# UNITED STATES PATENT AND TRADEMARK OFFICE

10/685,954

Todd M. Wenger

**Office Action Summary**

Sheet 9 of 21

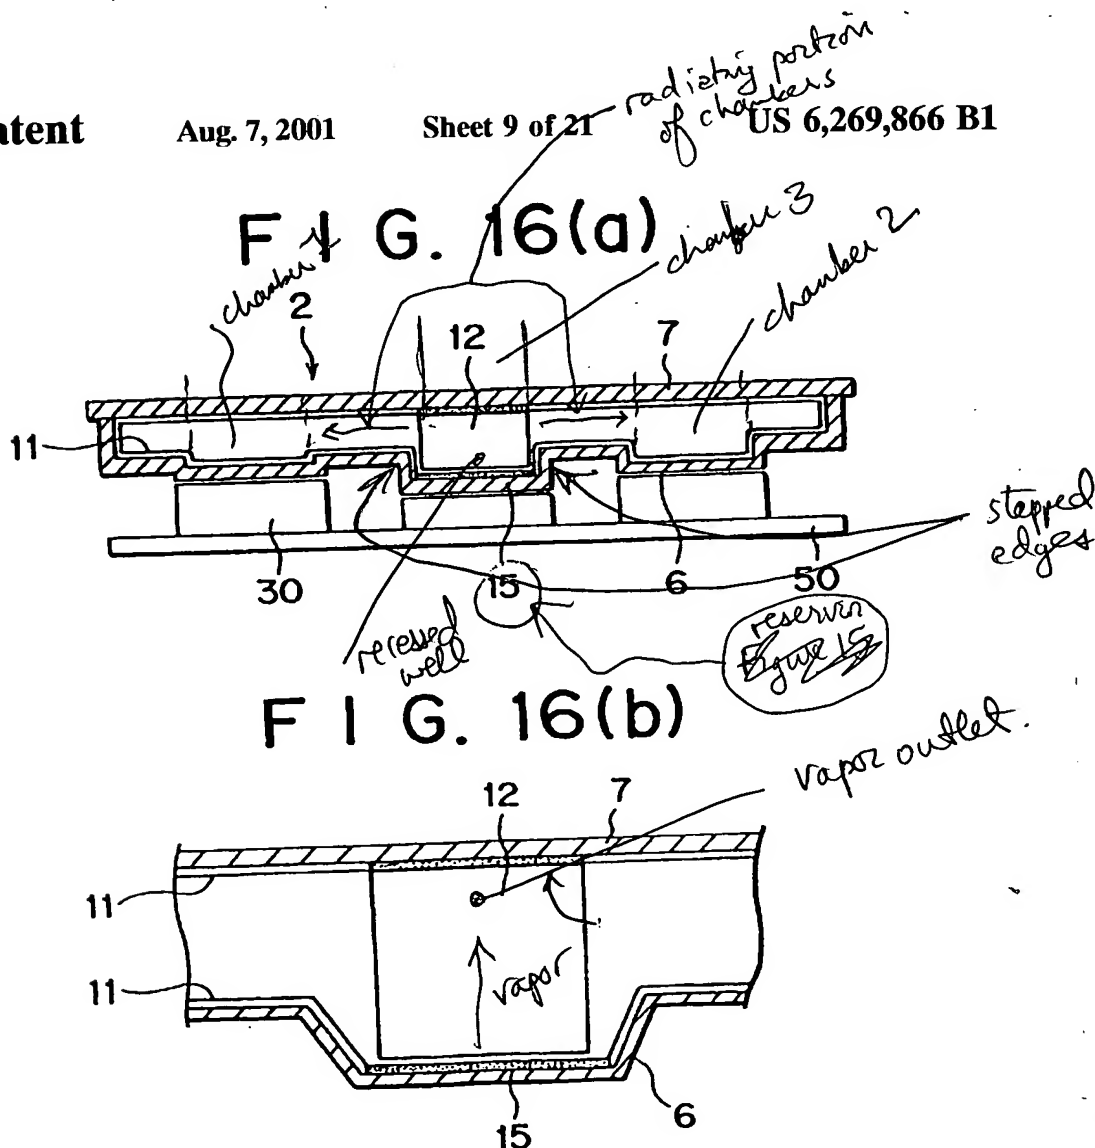
In particular regards to Figure 16, the central protrusion portion labeled 15 constitutes applicant's claimed "reservoir for the liquid phase." The wall area 6 above the two heat producing elements 30 on either side of the central protrusion portion 15 constitute applicant's "at least two spaced evaporation points." Regarding claim 4, see wicking material 11

Regarding claim 9, since a chamber, by definition, is simply an open space, for purposes of rejection the vertically projected area above each of the right-most, middle

and left-most heat producers 30 is deemed to be a chamber that radiates from the recessed well 15. Regarding claim 10, the chambers discussed immediately above being of different vertical depths are asymmetrically arranged relative to one another. Regarding claims 11-12, in col. 18, lines 55-60, Yamamoto discloses 100 Watt and 5 Watt heat loads. The 100 Watt heat load is located under the central recess portion. For claim 13, see Figure 27b, and for purposes of rejection, one chamber is defined over both 15e and 15d, absent any precise limitation in the claims as to what constitutes a chamber. See diagram below.
